Subject: Duke Power Company  
McGuire Nuclear Station  
Docket Numbers 50-369 and -370  
Catawba Nuclear Station  
Docket Numbers 50-413 and -414  
Topical Report DPC-3004-P, "Mass and Energy Release and Containment Response Methodology"; Response to NRC Questions

Attachment III  
Responses to Questions  
(Non-Proprietary Version)

## Response to NRC Questions on DPC-NE-3004

Figure 1

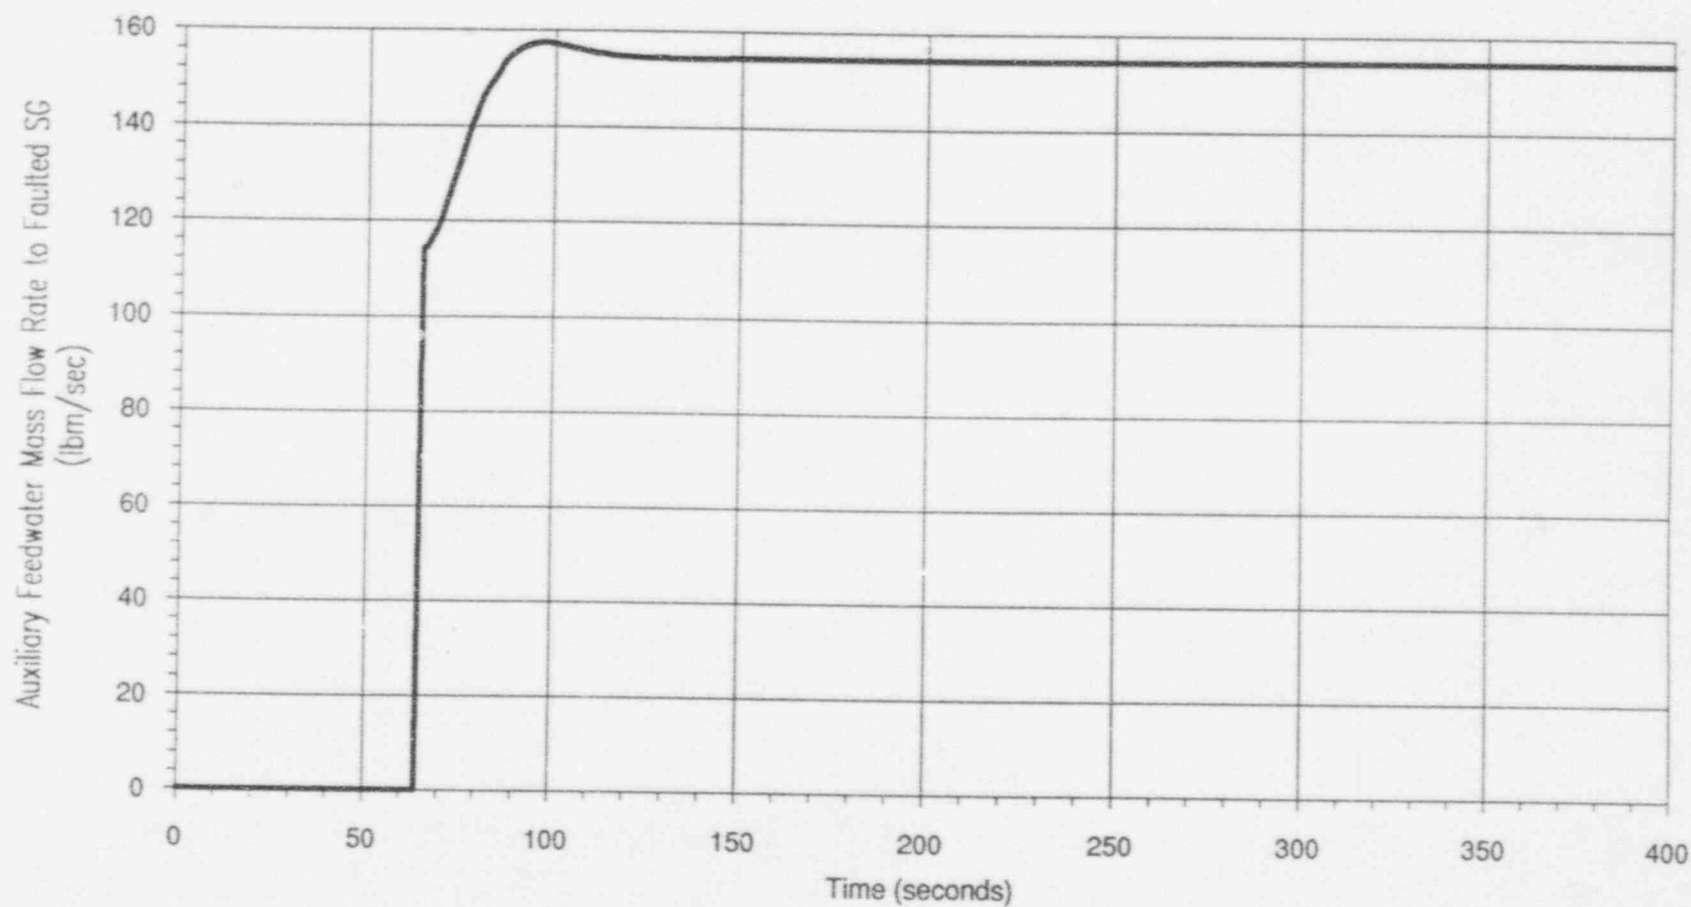
Referring to Fig 4-24, explain why such a large percentage of the total AFW flow is delivered to the intact S/Gs (instead of the faulted S/G which is at a much lower pressure). At what time is AFW flow to the faulted S/G terminated? Explain the differences between the AFW flow rate curves for W and BWI S/Gs (Figs 4.5.3 and 4.5.17).

The AFW flow rates plotted in Figures 4.5.3 and 4.5.17 represent the total AFW flow to the three intact steam generators and the AFW flow to the single faulted steam generator. Thus, AFW flow to the faulted steam generator (~ 1200 gpm) is nearly double that seen by each intact steam generator (~ 2000 gpm total or 670 gpm each).

AFW flow to the faulted steam generator is not terminated prior to the end of the mass and energy release analysis. Isolating AFW flow to the faulted steam generator would non-conservatively terminate the flow of steam through the break. Thus, the mass and energy release is analyzed with continued AFW flow past the time of peak containment temperature.

AFW flow is specified in the RETRAN input deck as a function of steam generator pressure with an enthalpy corresponding to a given temperature. For the Westinghouse preheater steam generators, a purge volume of hot water is assumed to be delivered before the cold AFW reaches the steam generators. For break sizes above 0.6 ft<sup>2</sup>, pressure in the faulted steam generator drops below the saturation pressure of the hot AFW before the purge of the hot AFW is completed. When pressure in the faulted generator falls below the saturation pressure of the hot AFW, it is assumed that the water in the AFW piping flashes and is added to the faulted generator as steam. Thus, a sharp increase in the volumetric AFW flow rate is seen between 65 and 85 seconds in Figure 4.5.17 due to the much lower density of the steam. Figure 1 shows the AFW mass flow rate to the faulted steam generator that corresponds to the volumetric flow rate shown in Figure 4.5.17.
